**Re:** 3441 Broad Street Special Use Review, plan dated May 4, 2015  
Alternative plan A1.01alt and A1.01altB dated, May 27, 2015  
Applicant: Craig Borum, Ply Architecture  
Project: Strawberry Alarm Clock  
Zoning: VR Village Residential

## Combined Site Plan Review For City of Dexter, Michigan

Regarding: Strawberry Alarm Clock Café  
**Combined Site Plan - Review No. 2**  
OHM JN: 0130-15-1011

Subject: Plan review of: Strawberry Alarm Clock Cafe  
Plans dated: June 5, 2015

### NEIGHBORING ZONING AND LAND USE

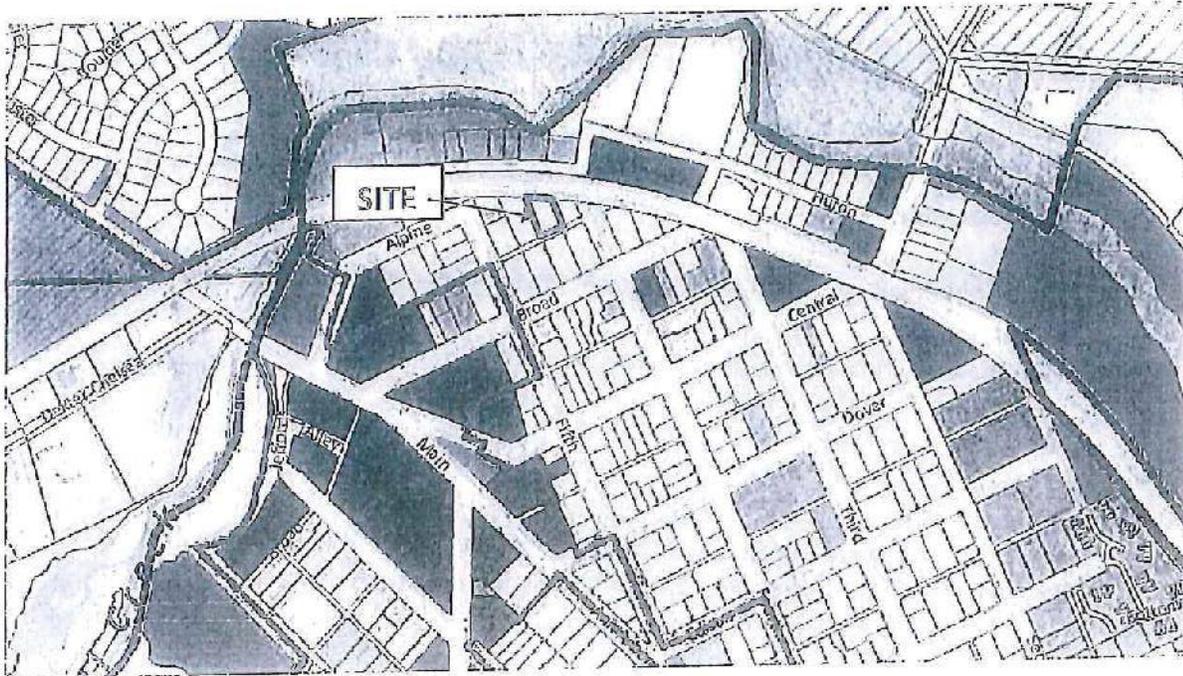
*Items to be Addressed: Compatibility of the proposed use on the existing residential neighborhood, specifically, compatibility to the west and south.*
